**WHITE LAKE TOWNSHIP
INTER-OFFICE MEMORANDUM**

**SUBJECT: White Lake Retail Management LLC
Preliminary Site Plan Approval**
Located on the north side of Highland Road (M-59) and west of Fisk Road.
Consisting of approximately 1.8 acres. Currently zoned (GB)
General Business. Identified as tax parcel 12-23-201-010.

RE: 9328 Highland Road- Commercial Building with Drive Thru- Preliminary Site Plan Review – 1st Review

Subject: 9328 Highland Road
Preliminary Site Plan Review
Zoned: General Business (GB) District

DRAWING: **C-3**

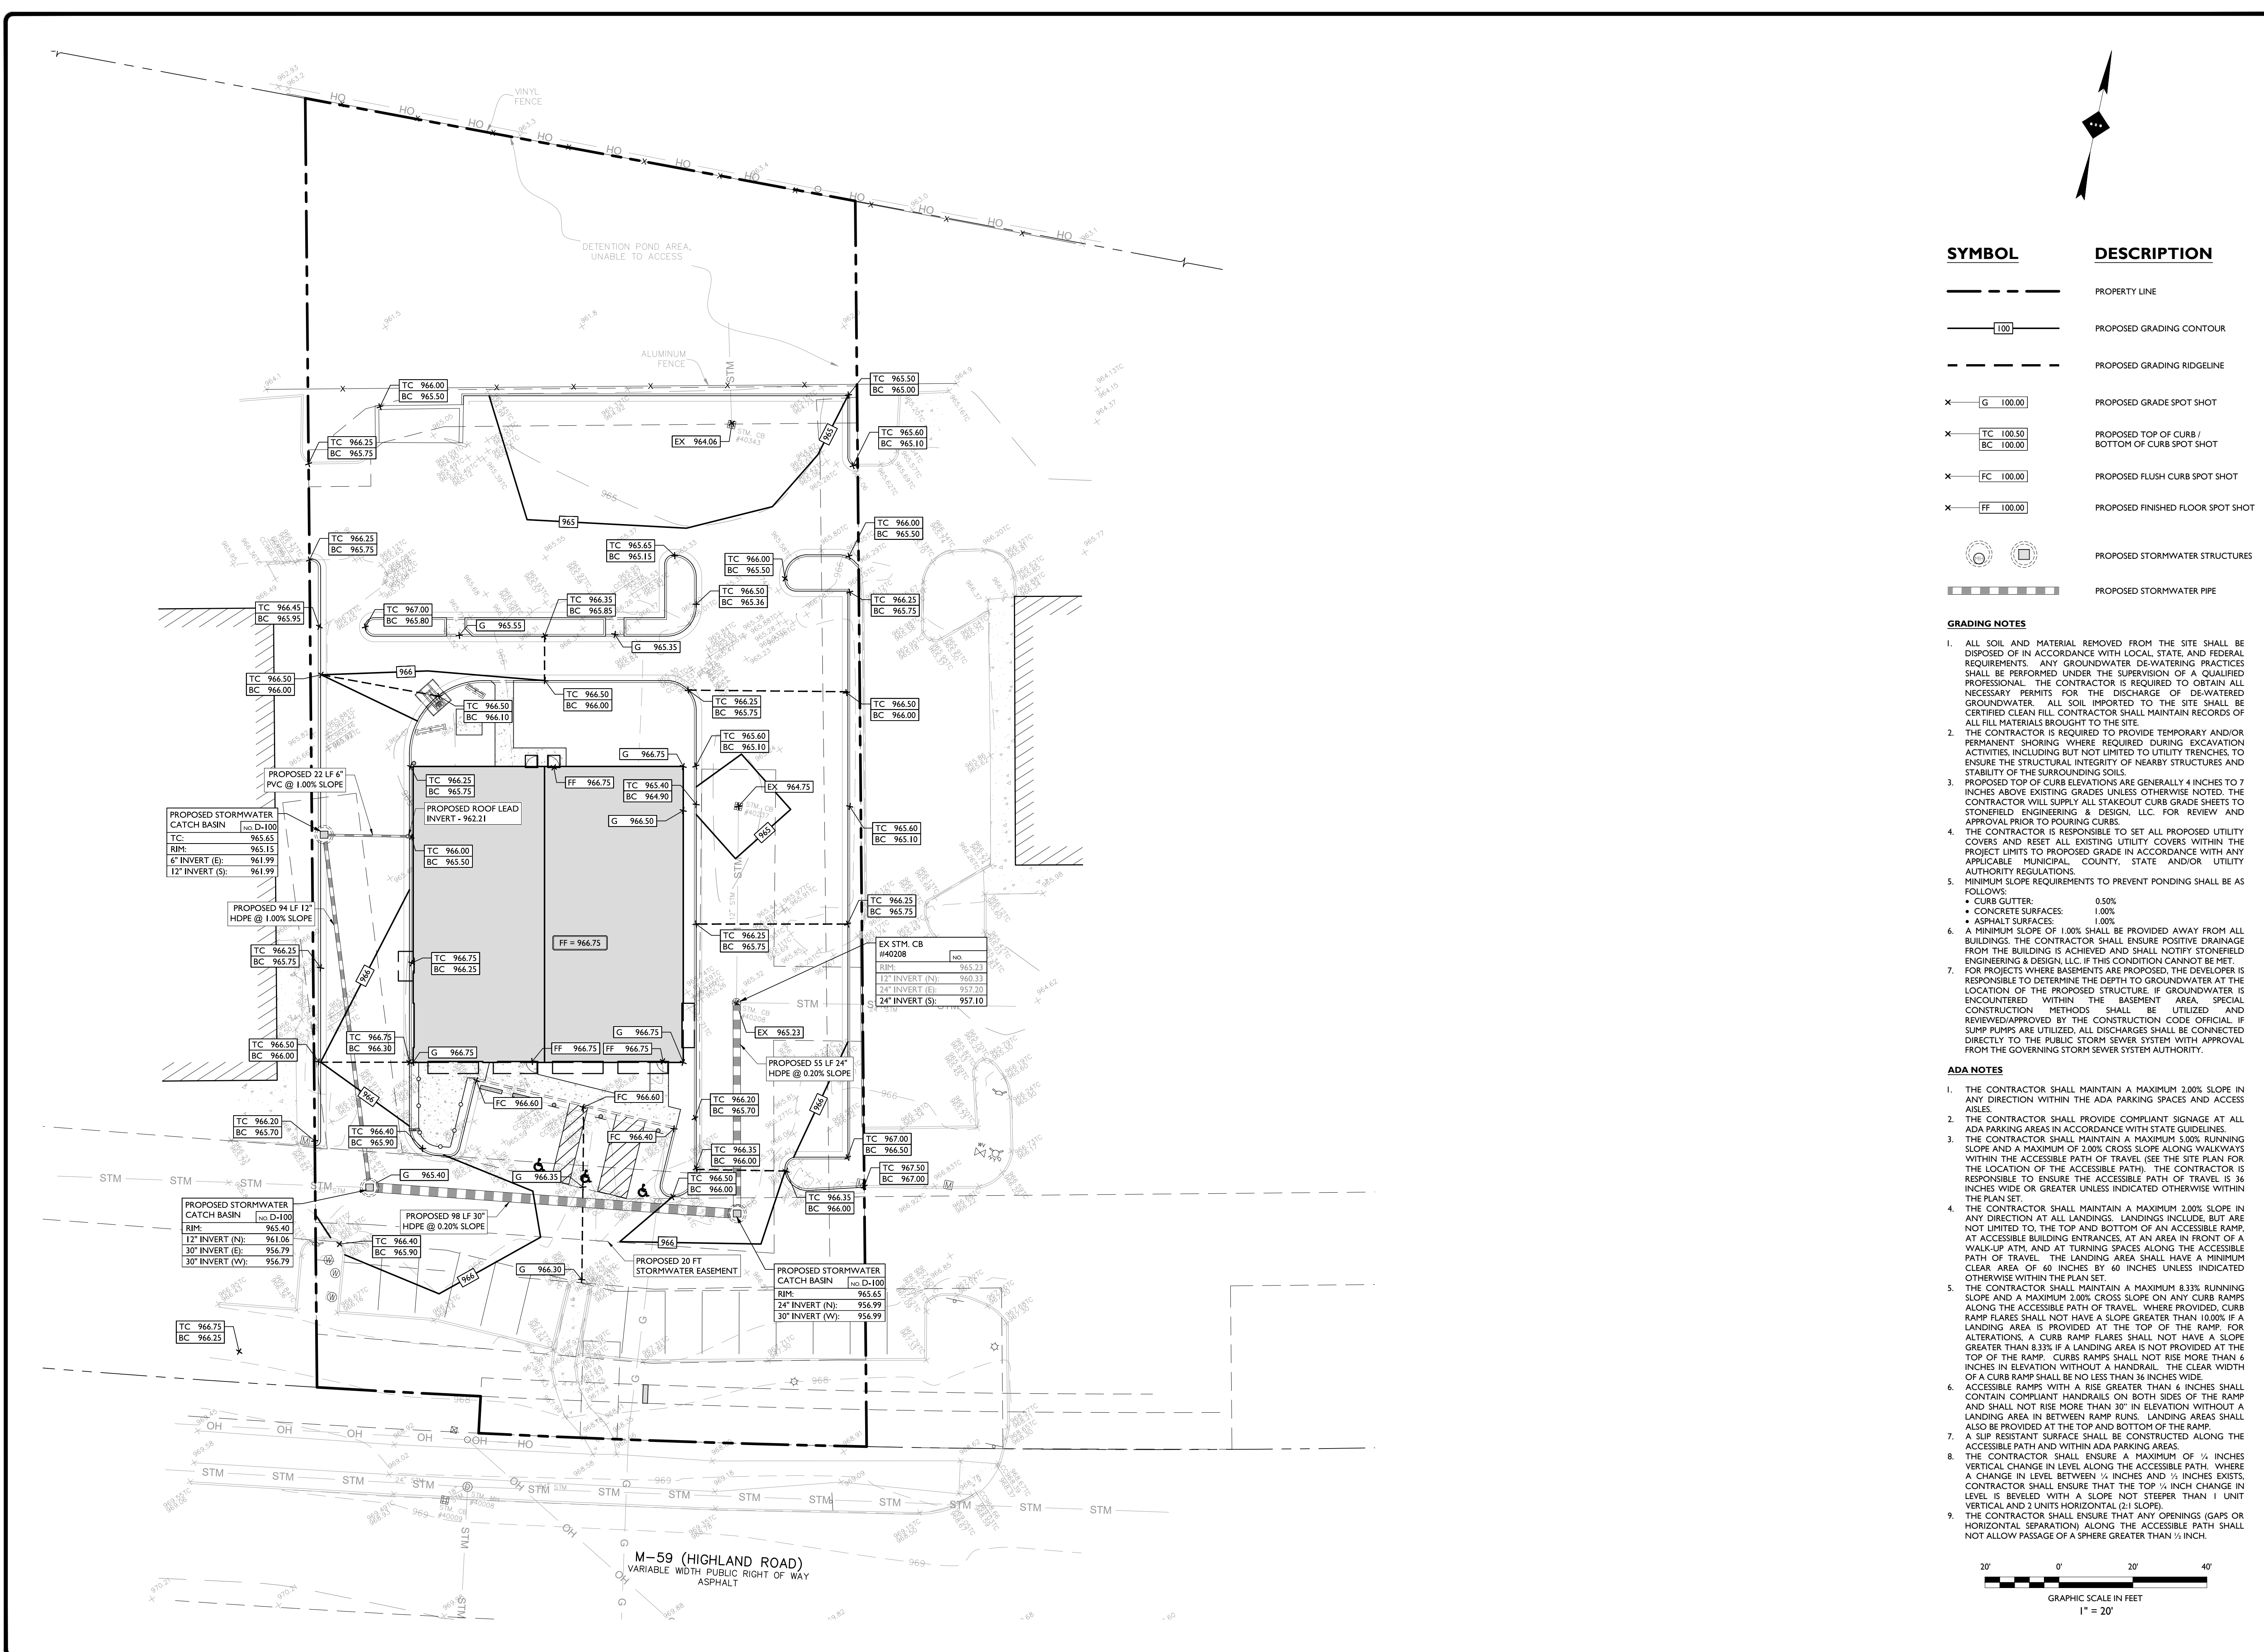
Staff Planner Quagliata noted that the sidewalk along the front is 5 feet, it's okay because the parking space is 19' in depth. The sidewalk in the rear will need to be 7' wide.

Commissioner Carlock questioned the 5' sidewalk in the front. She said the bumpers get messed up after a year or so and she feels the 5' is too narrow. Commissioner Slicker is in agreement.

9. The plan appears to propose 5 foot wide sidewalk in front of the building, ordinance requires 7 foot walks to account for vehicle overhang. This may be allowable as the plans propose either bumper blocks or handicap signs in front of the spaces which would prevent overhang. We defer further comment to the Planning Department or Planning Consultant.
-

DRAWING: **C-5**

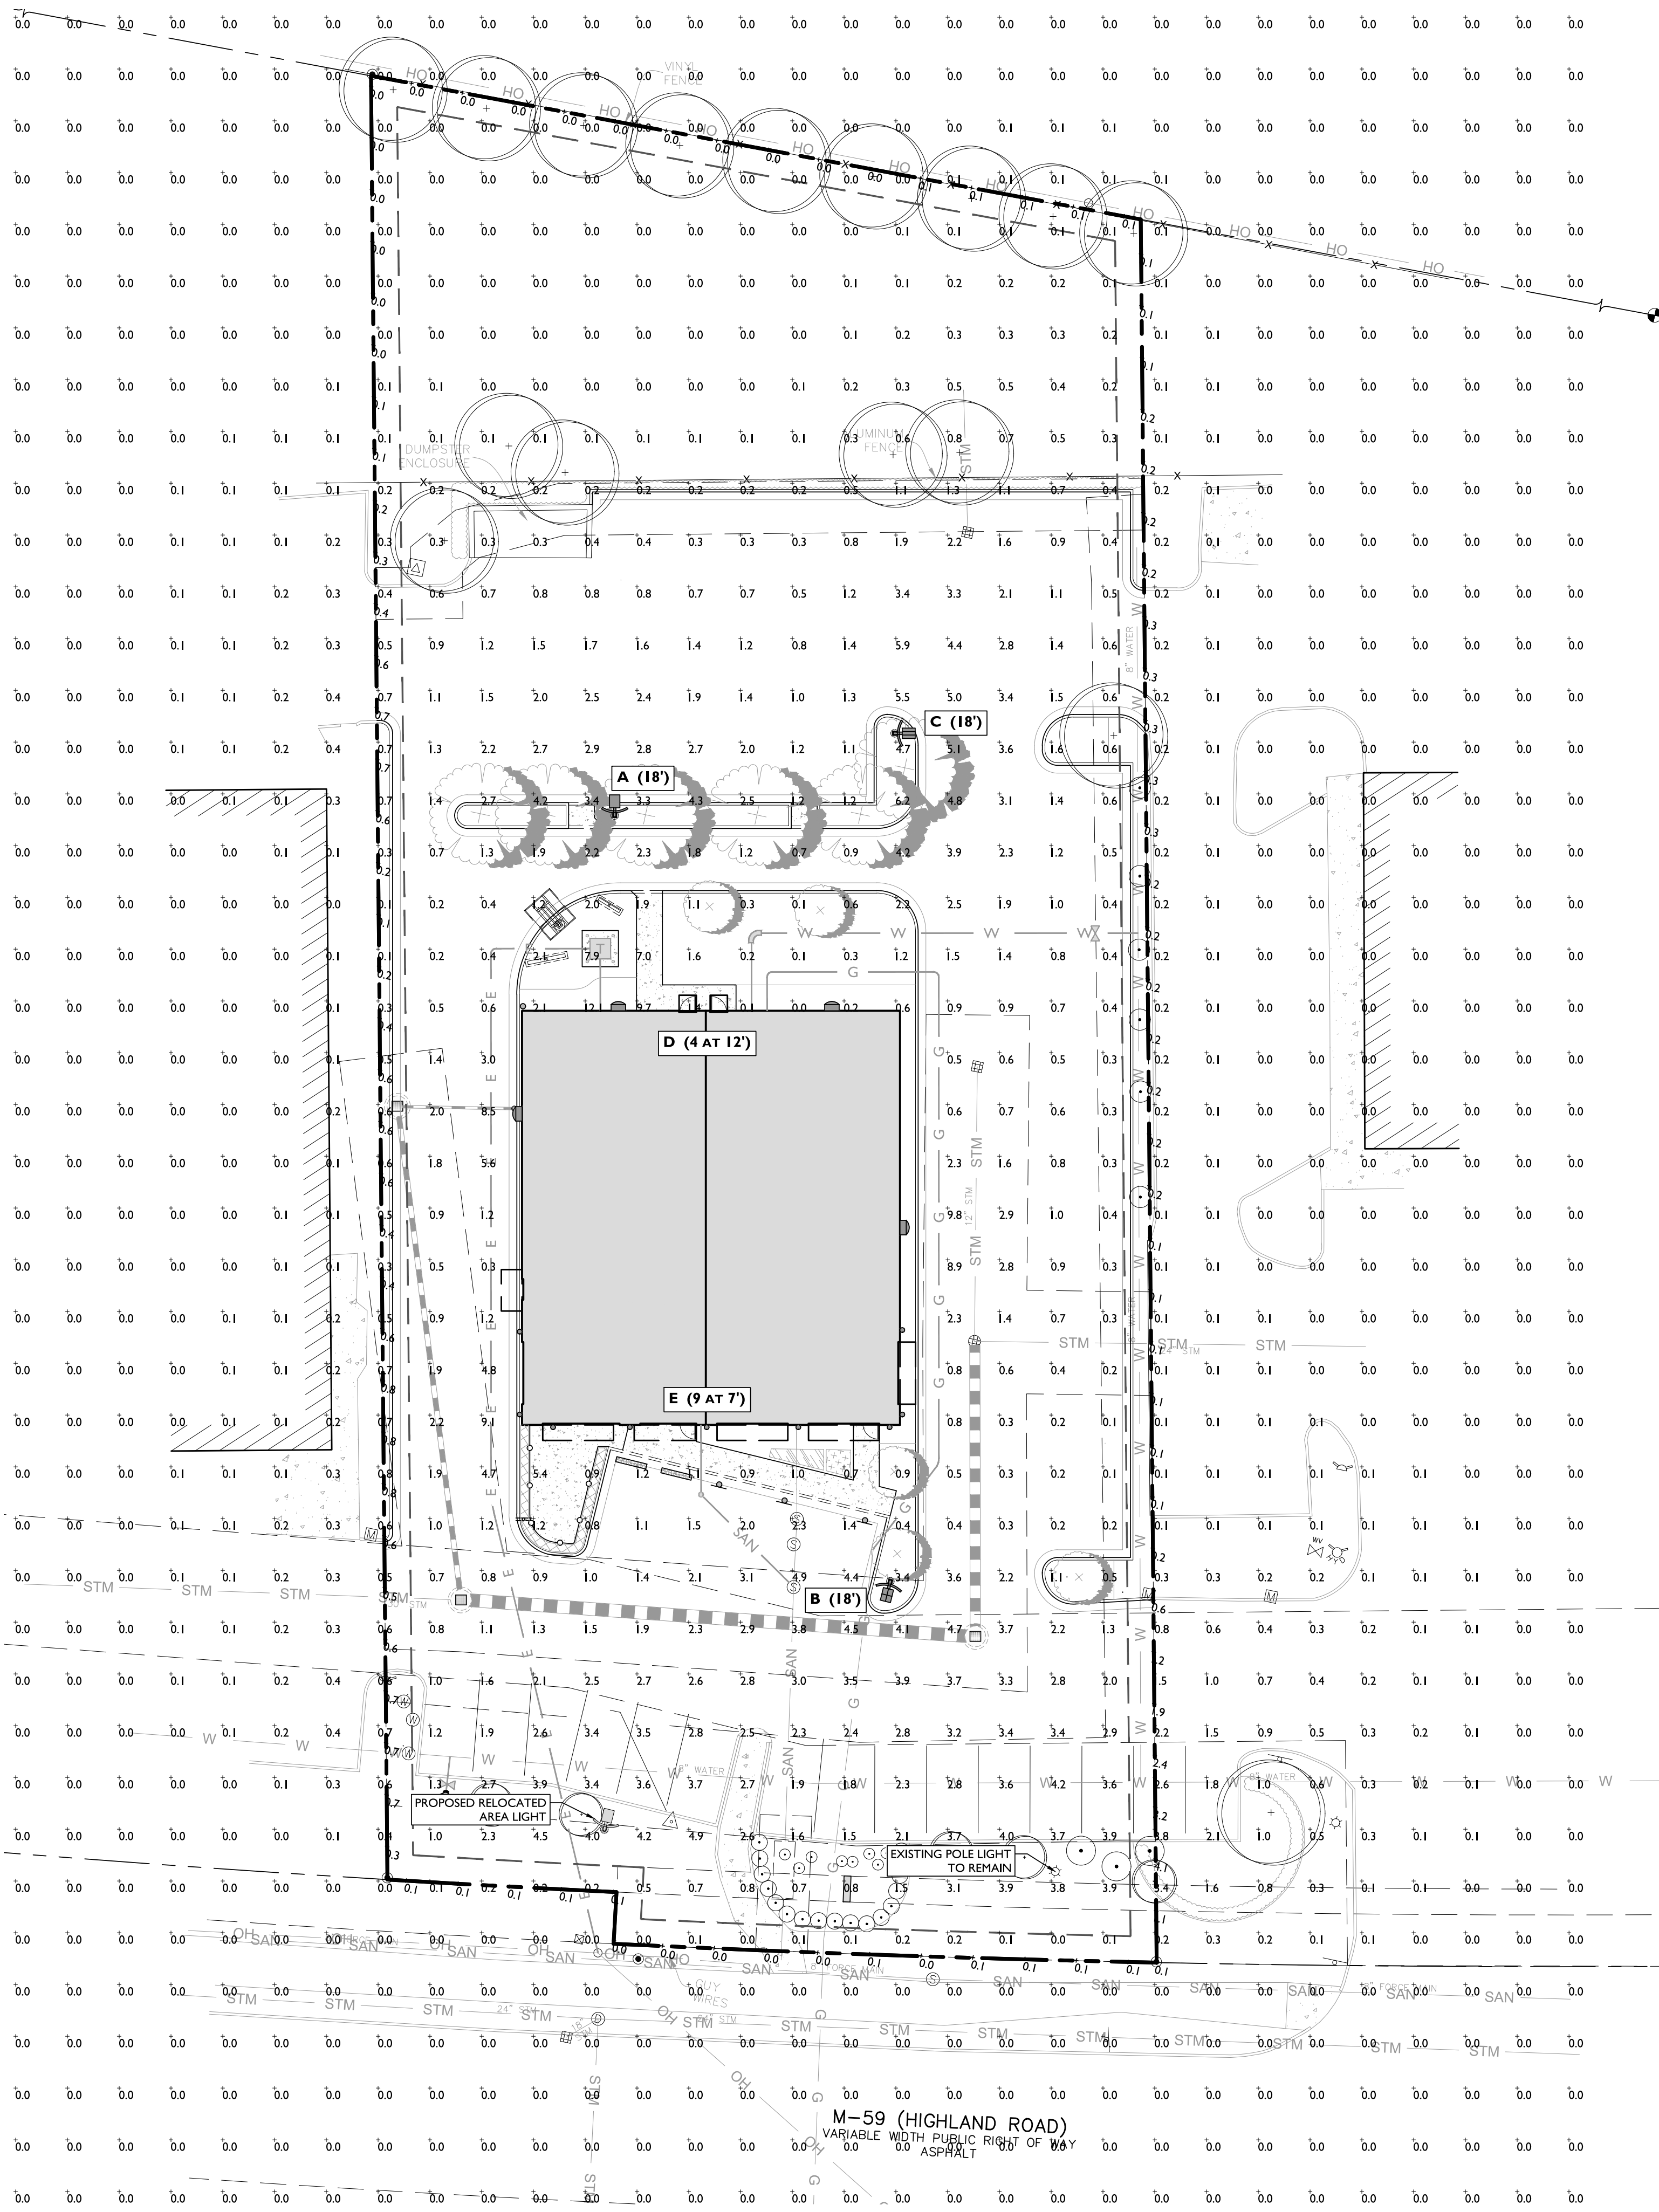
1. The access drive shall be designed and maintained to support the imposed loads of fire apparatus and shall be surfaced so as to provide all weather driving capabilities.
2. The required turning radius shall accommodate the largest Fire Department apparatus (40')
3. The angle of approach/Departure to and from White Lake roads shall not exceed 8 degrees.
4. The proposed relocation of the existing fire hydrant on drawing C-5 has Fire Marshal approval.
